**PHRC- Renovation Project 2nd Floor Suite
Columbia, South Carolina
University Project Number FP00000192**

January 18, 2019

ADDENDUM No. 2

PROJECT NUMBER: U-17-039-1
 SHEET NUMBER: A801
 SHEET NAME: DOOR/FINISH SCHEDULES
 DATE: 12.20.18

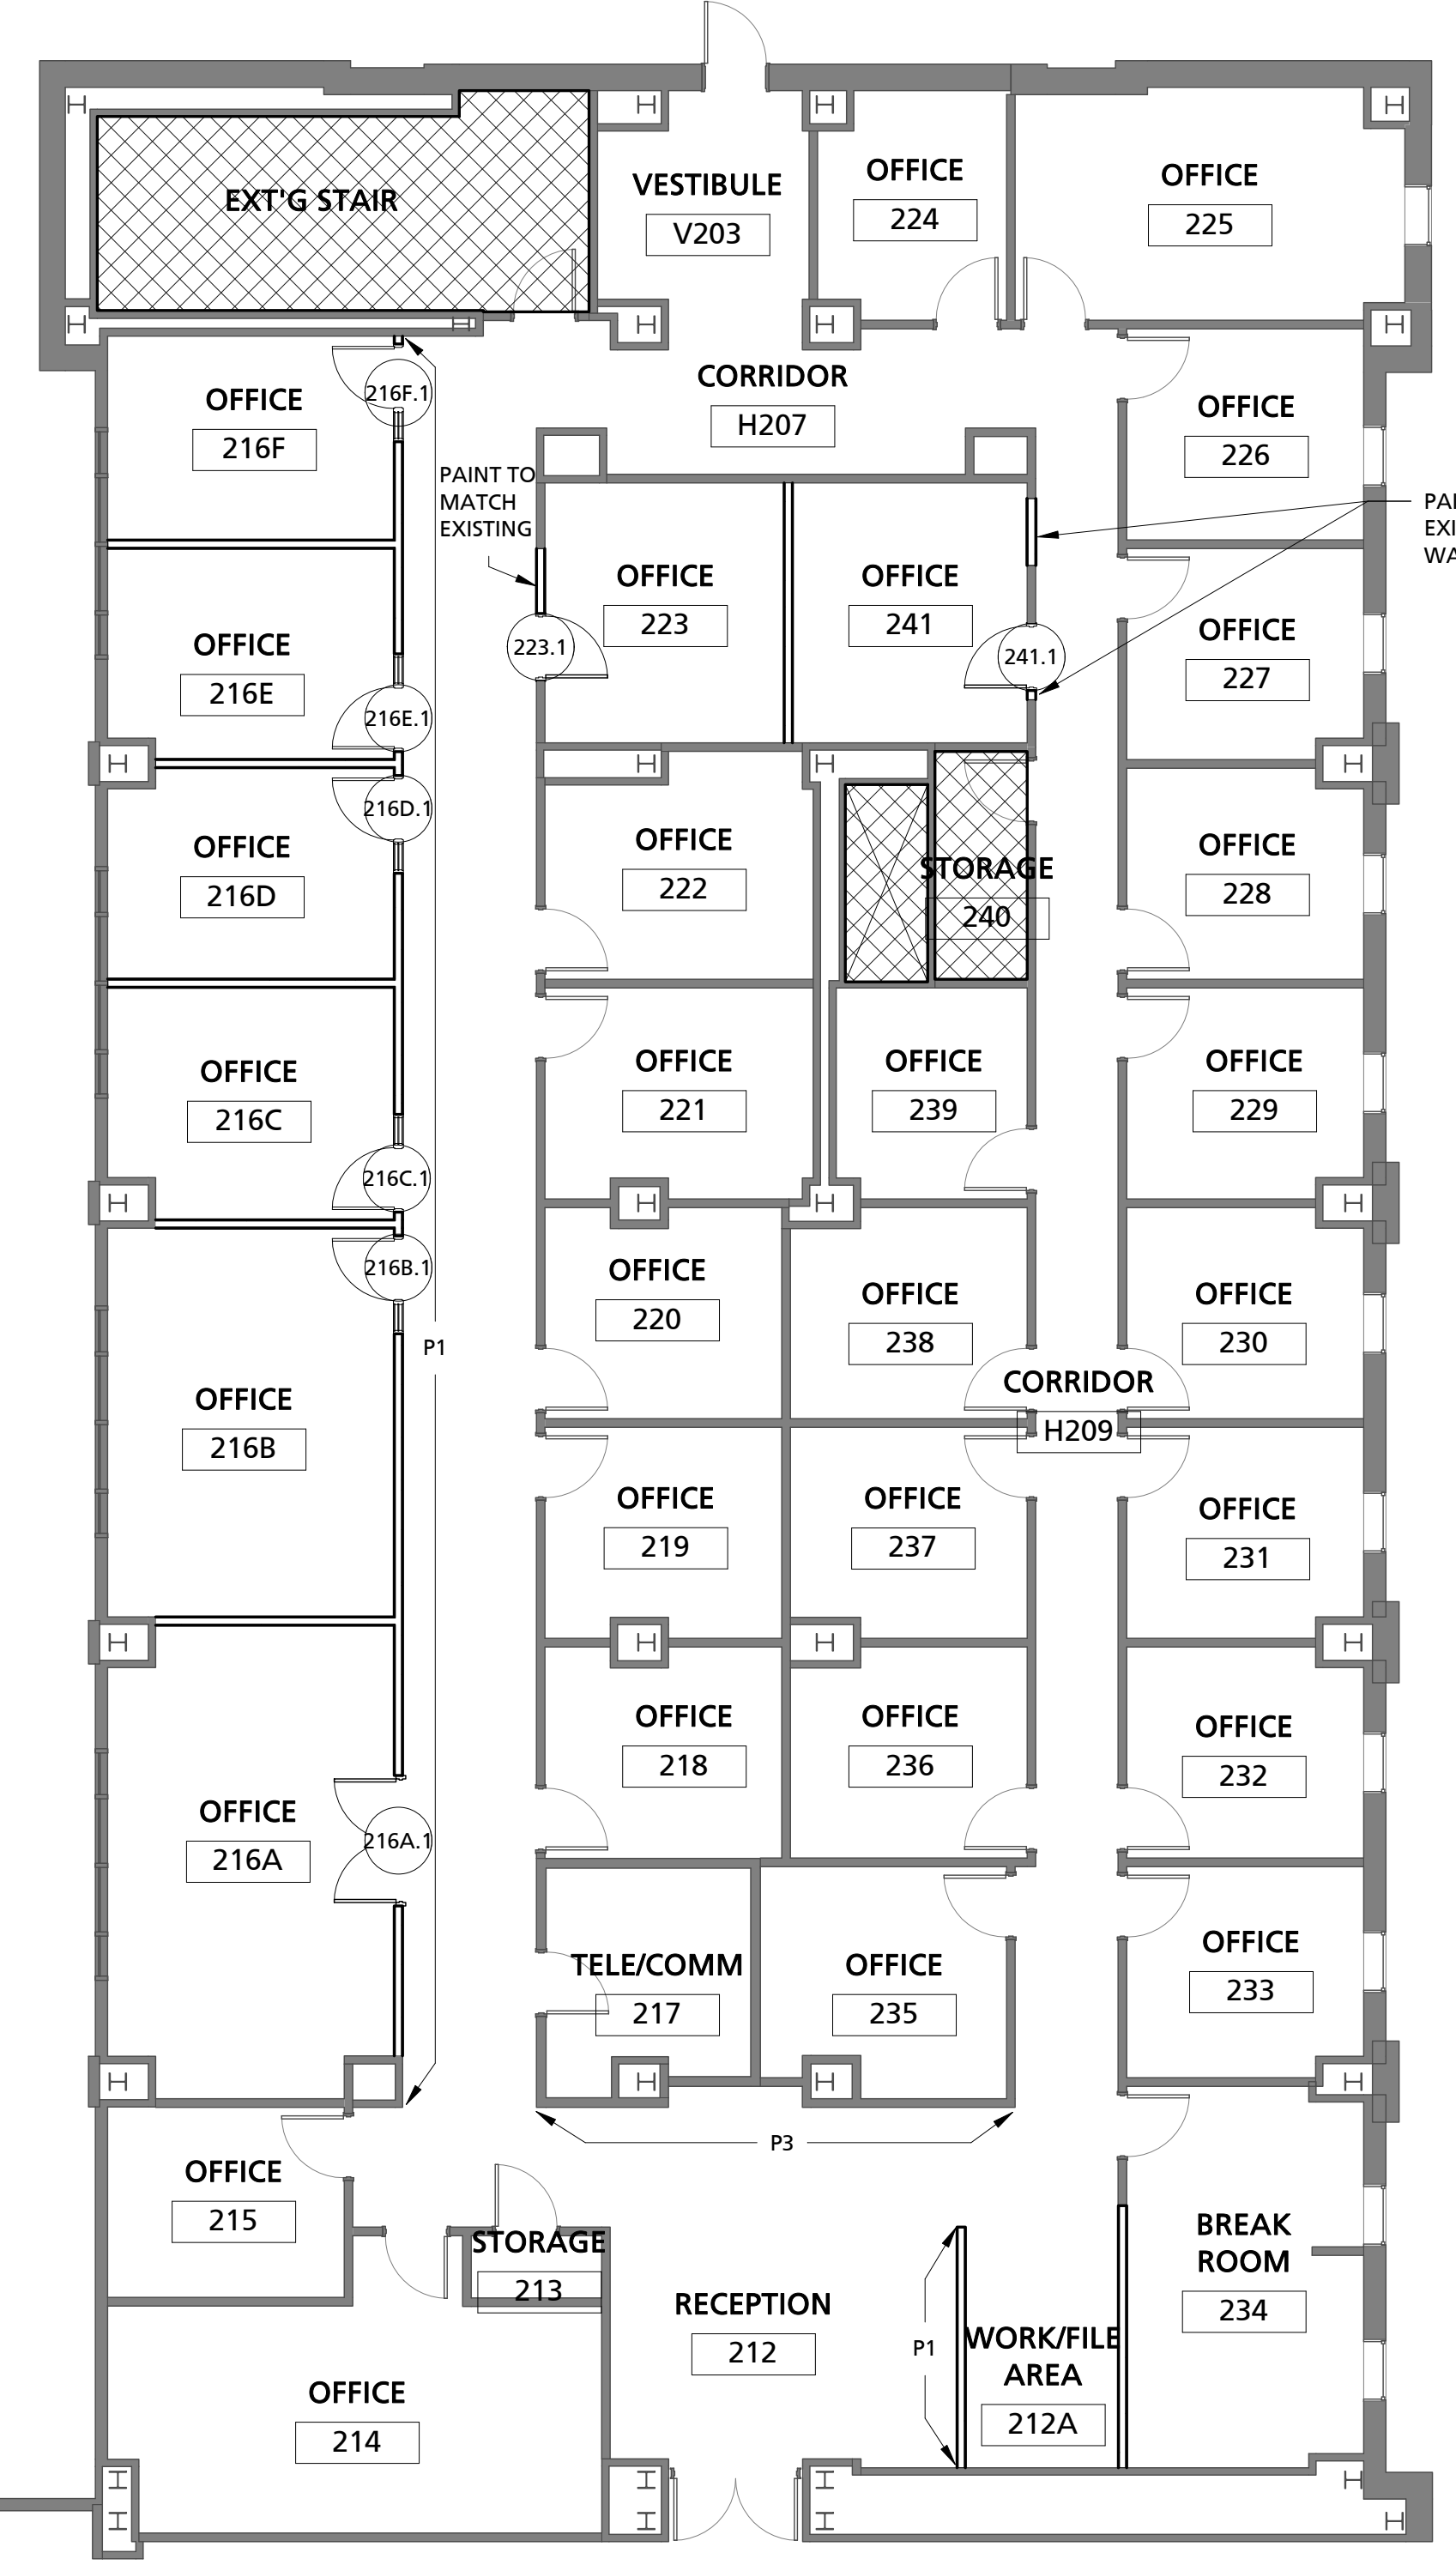
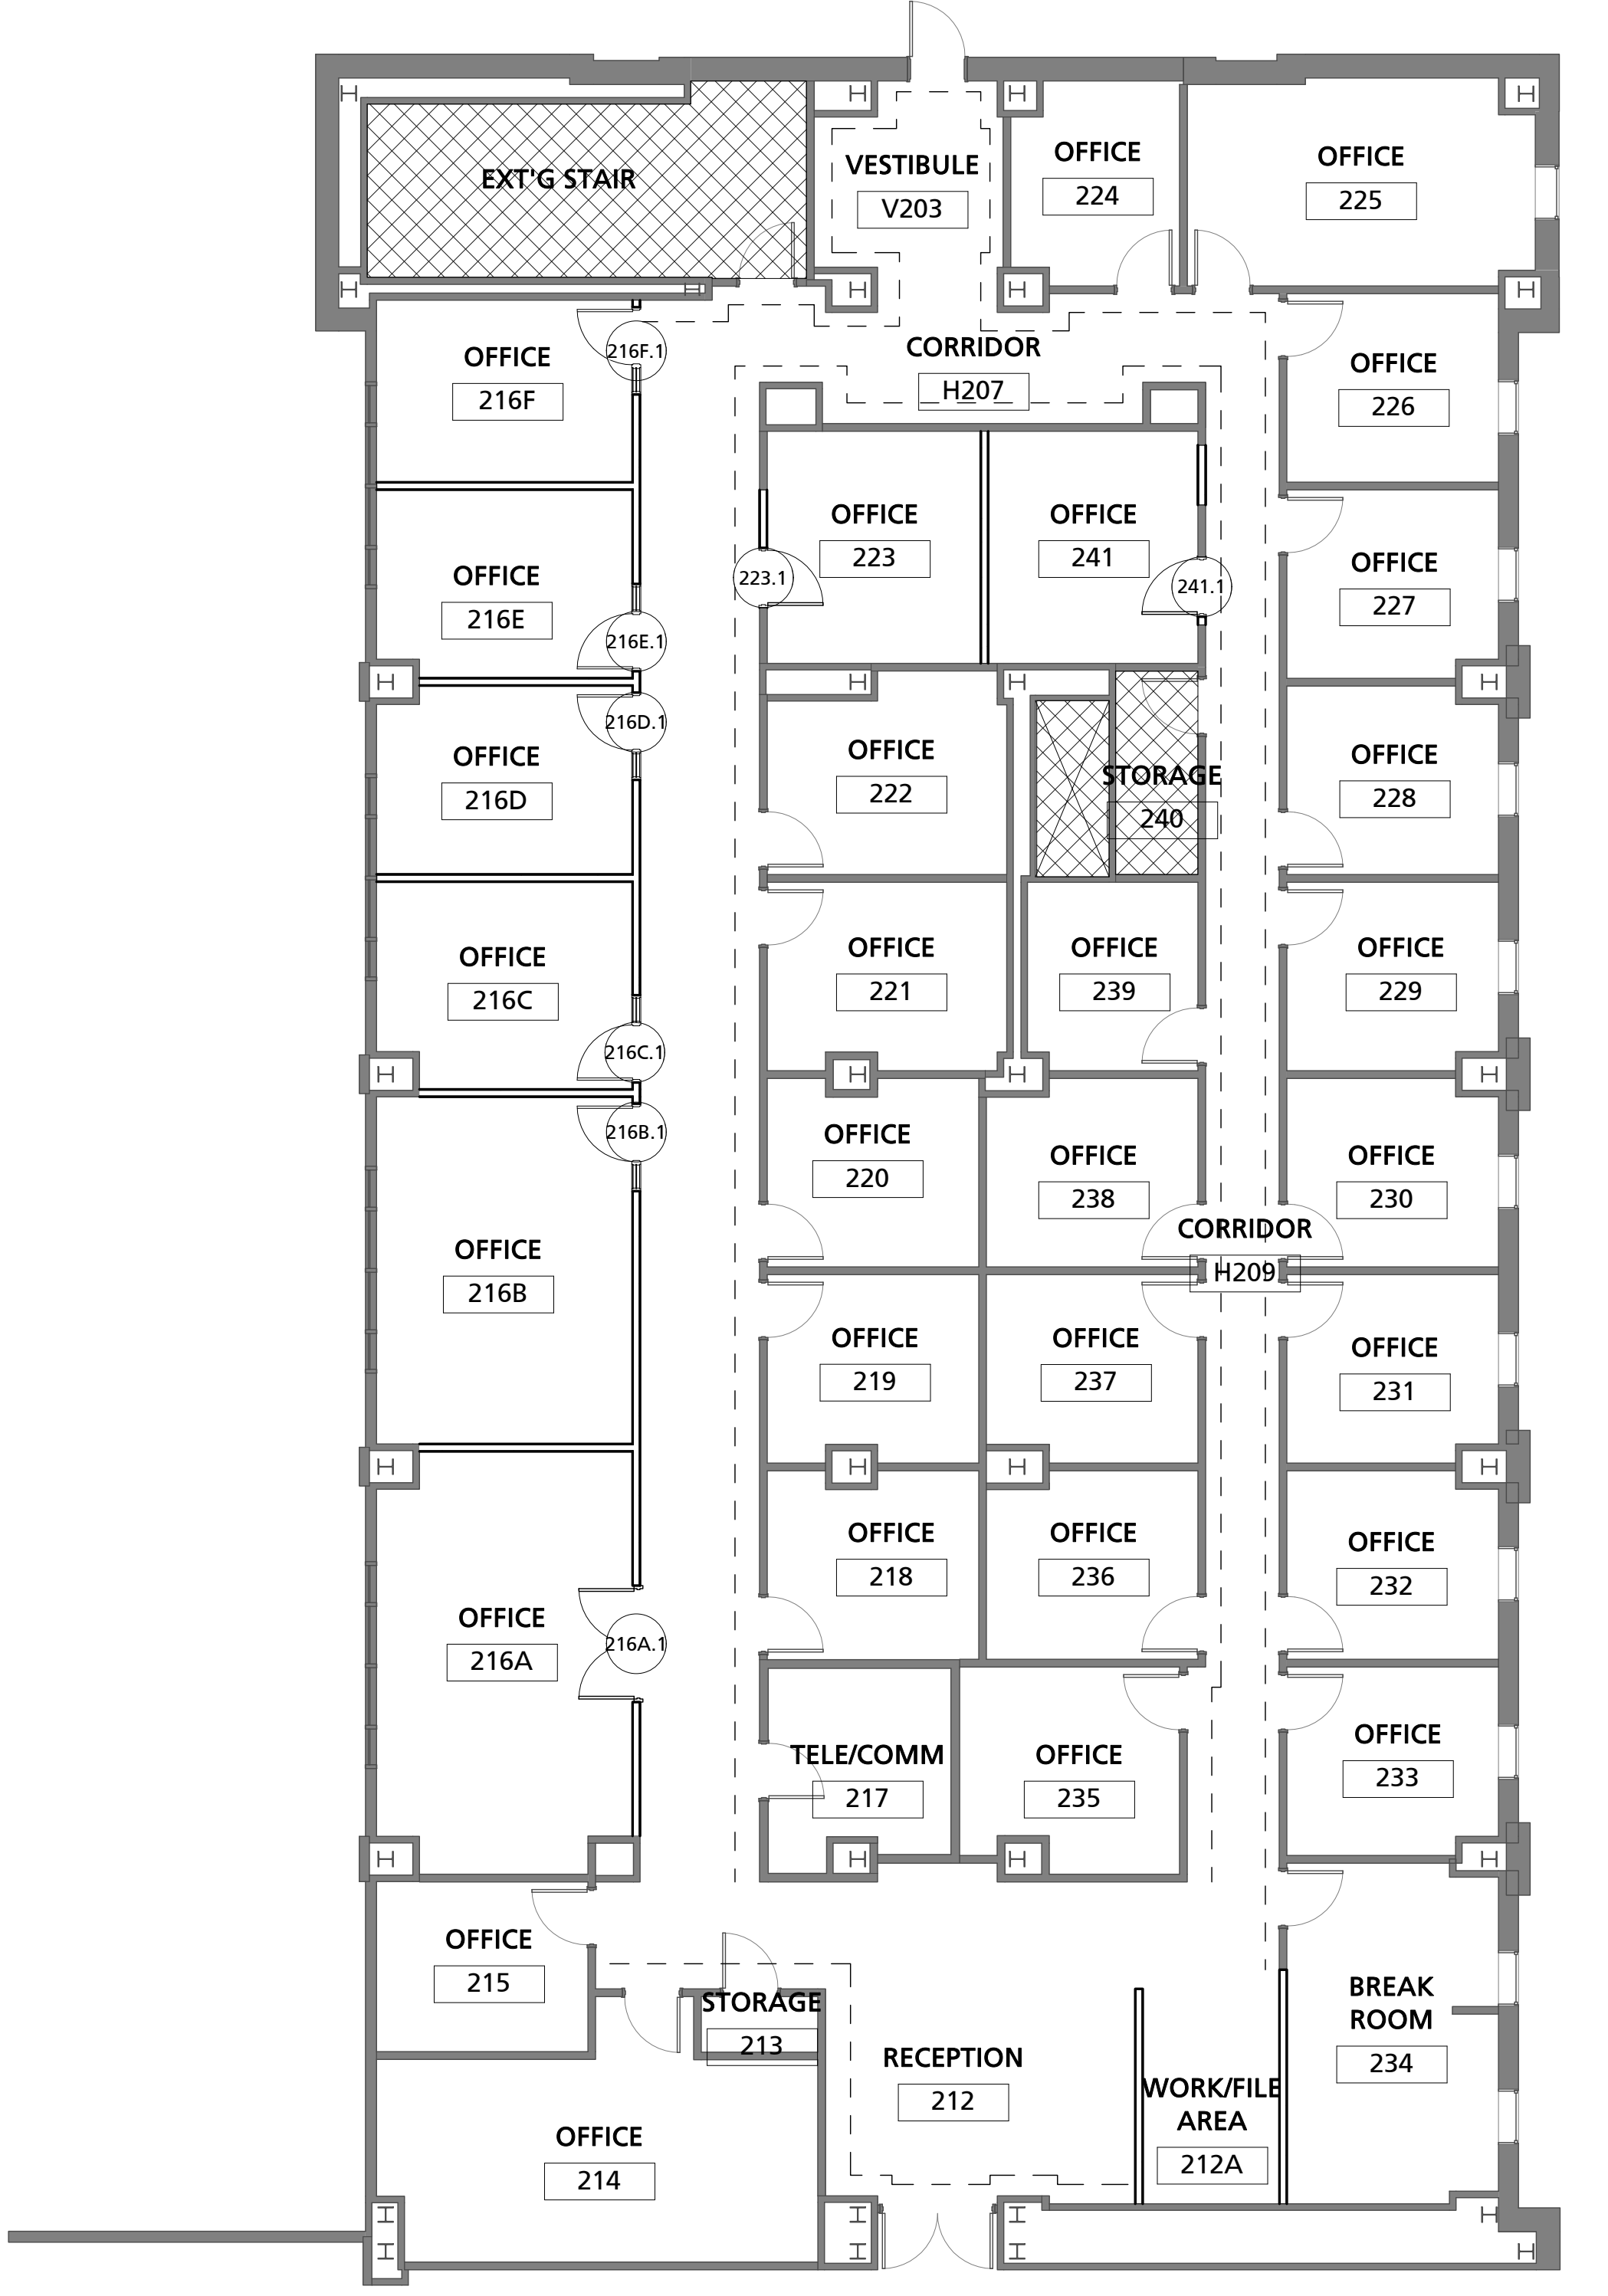
1. Reference Sheet A801, dated 12.20.18: DELETE Sheet and ADD in its place Sheet A801, dated 12.20.18, revised 01.18.19, attached.
 - a. Clarifications to DOOR SCHEDULE.
 - b. Clarifications to FRAME TYPES.
 - c. Clarifications to GENERAL INTERIOR FINISH NOTES.
2. ADD Sheet FP 101, dated 12.20.18, revised 1-18-19, attached.
 - a. Clarifications to Fire Protection.
3. Reference Sheet CVR, dated 12.20.18: DELETE Sheet and ADD in its place Sheet CVR, dated 12.20.18, revised 01.18.19, attached.
 - a. Clarifications to DRAWING LIST.

5. Frame type 2 on sheet A801 shows the frame height the same height as frame type 1 which is 8'-0" in height. The Door Schedule shows the doors for this frame as 84" in height. Should this frame have a transom over the doors? Please clarify.

- a. See MODIFICATIONS TO DRAWINGS, this Addendum.
6. I could not find a questions deadline for this project listed/posted. Can you confirm what it is?
